**APPLICATION FOR PERMISSION
UNDER SECTION 16 OF
THE TOWN PLANNING ORDINANCE
(CAP. 131)**

Revised drainage design is prepared to address the previous comments issued by Drainage Services Department (DSD) issued via the letter from Planning Department dated 8 October 2024 (Planning Department's Ref: DPO080824OB-B8354) (see **Annex 1**).

**Proposed Temporary Vehicle Park (Medium and Heavy Goods Vehicle) and Open Storage
(Operation Tools and Materials) for a Period of 3 Years and Filling of Land
in “Residential (Group D)”, Lot 82 S.B ss.1 (Part) in D.D.108,
Fan Kam Road, Pat Heung, Yuen Long
(Planning Application No. A/YL-PH/933)**

**Compliance with Approval Condition (e)
Submission of a Revised Drainage Proposal**

DRAWING TITLE :
E&M INSTALLATIONS (1)

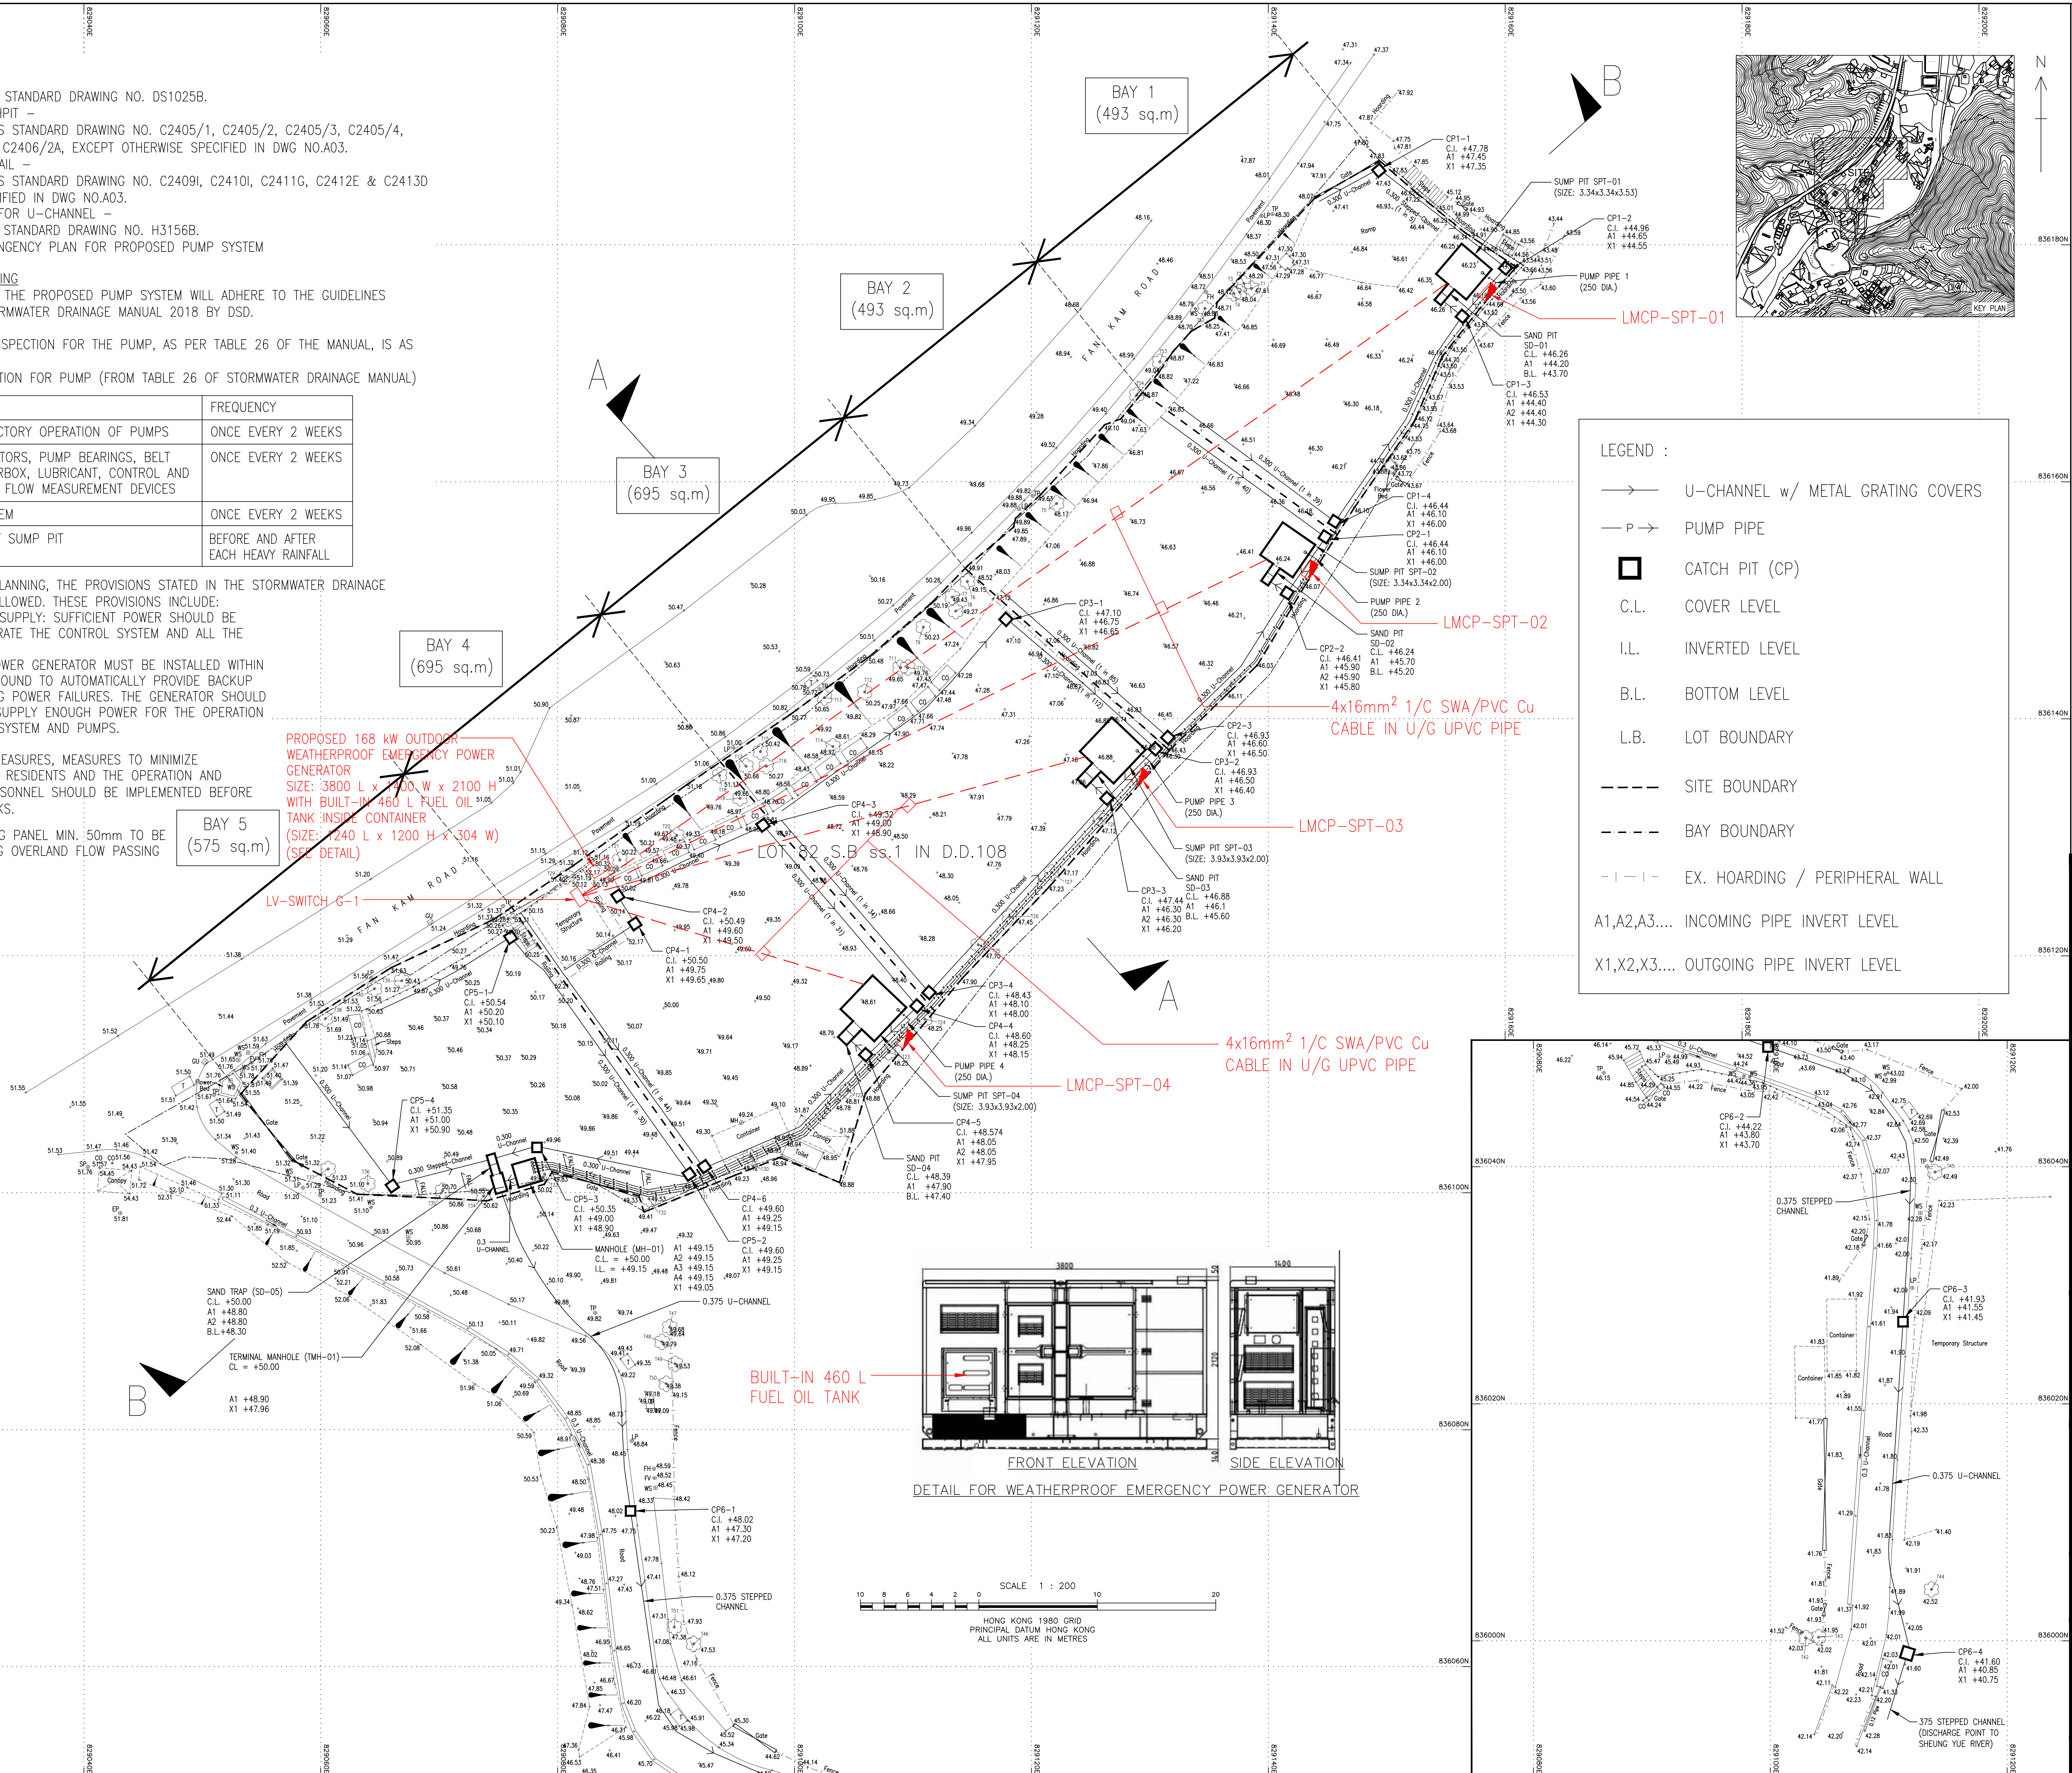
(i)	Please advise whether emergency power generator will be provided for the proposed drainage system and indicate the location for installation of the generator.	Yes. The emergency power generator will be provided for drainage pump system. The location of the proposed Generator as shown in drawing no. E01 in Annex 2.

Pump Performance Curves

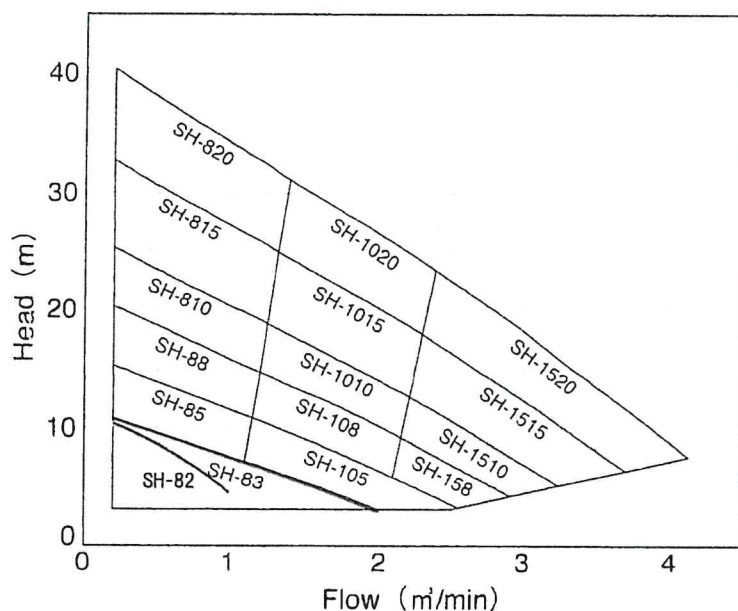
installed in any machinery / forming part of any machinery and its capacity not exceeding 500 Lit.
(l)	Two stage pumping will be operated at each sump pit. Please include the performance curve for tow stage pumping in the submission.	Two stage pumping operation procedure as stated in drawing no. E-02 - Section B-B. details as follows:- - 1st duty water pump to the specified water level will be operated. - 2nd duty water pump to be operated when the water level high than or exceeding the specified water level of the 1st pump. The performance of selected water pump (each pump) remains unchanged. Please refer attached pump curve extracted from the manufacturer.
